## OPERATIONS DIVISION

**SUMMARY OF THE TECHNICAL REVIEW OF THE  
SAFETY ANALYSIS REPORTS FOR PACKAGING (SARP)  
FOR THE TRANSNUCLEAR TRANSPORT/STORAGE CASKS:  
TN-BRP AND TN-REG**

Date Published - July 1986

Fig. 12. TN-REG Fuel Basket Loading Configuration for final SARP. O indicates position of assembly with no BP rods. X indicates position of assembly with only 8 BP rods. All other basket compartments contain assemblies with full BP rod cluster.

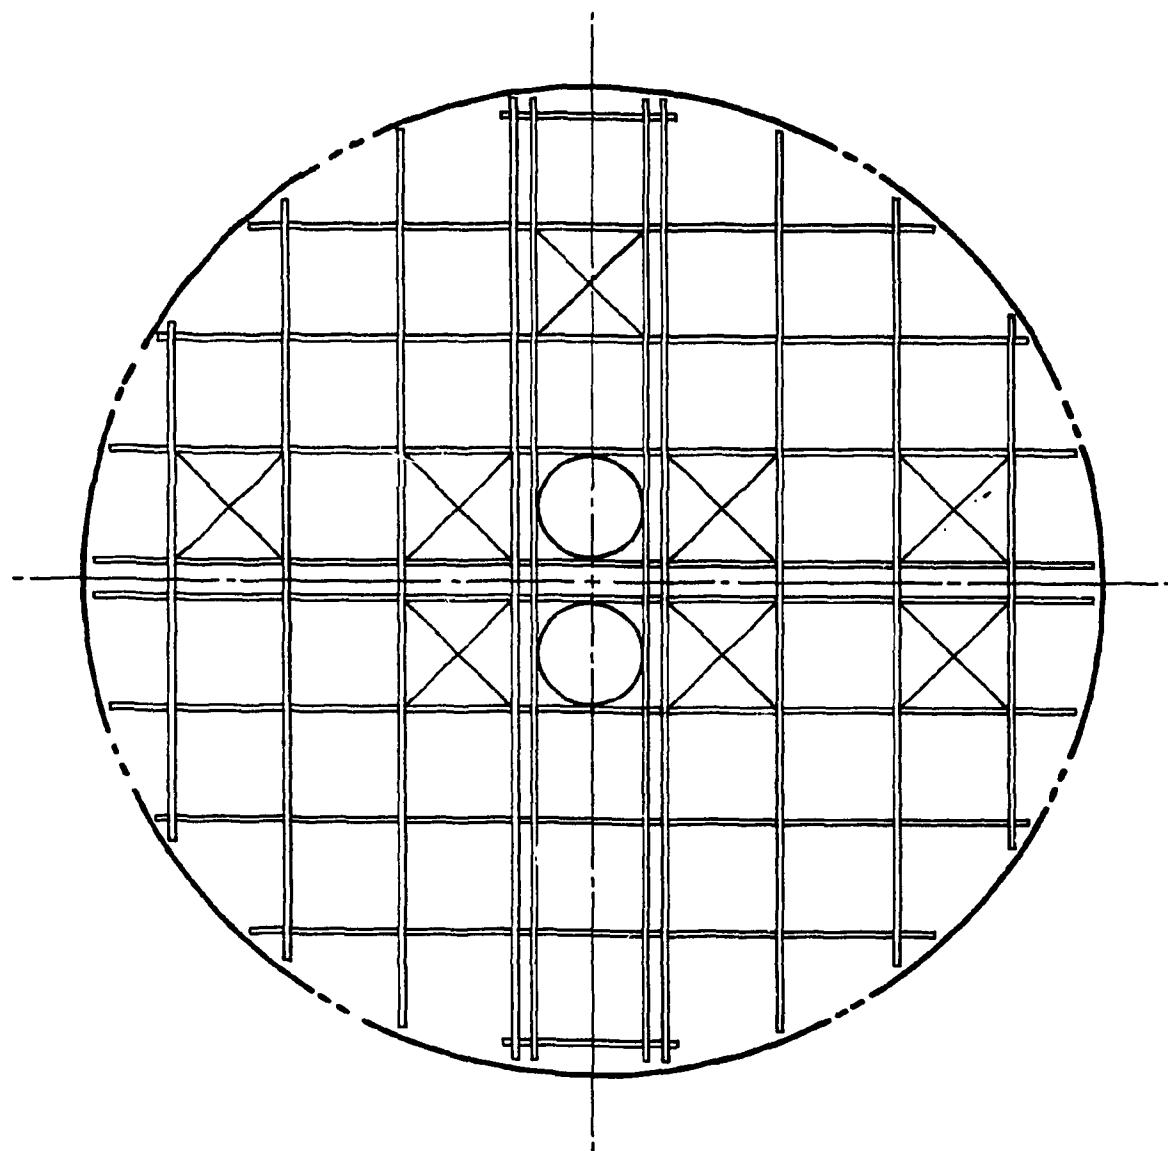
The criticality model was changed in going from the last draft SARP to the final SARP because in attempting to verify the fuel assemblies in the West Valley pool, West Valley Nuclear Services (WVNS) discovered an additional assembly with no BP rods present. Thus, Table 6.1 and the calculational model of the SARP were altered in the final SARP to indicate eight assemblies with only eight BP rods and two assemblies (I.D. C17 and C40) with no BP rods present. This verification project was performed by WVNS and the findings were reported verbally to C. V. Parks of the ORNL review team by J. A. Eggert of WVNS. DOE should seek written confirmation of the verification process and findings from WVNS prior to approving the SARP or cask loading scheme shown in Fig. 7-4 of the SARP. The loading

pattern in this figure is acceptable from both criticality and shielding considerations. However, again DOE needs to ensure that administrative procedures are in place at WVNS to load the cask in accordance with the specified loading pattern.
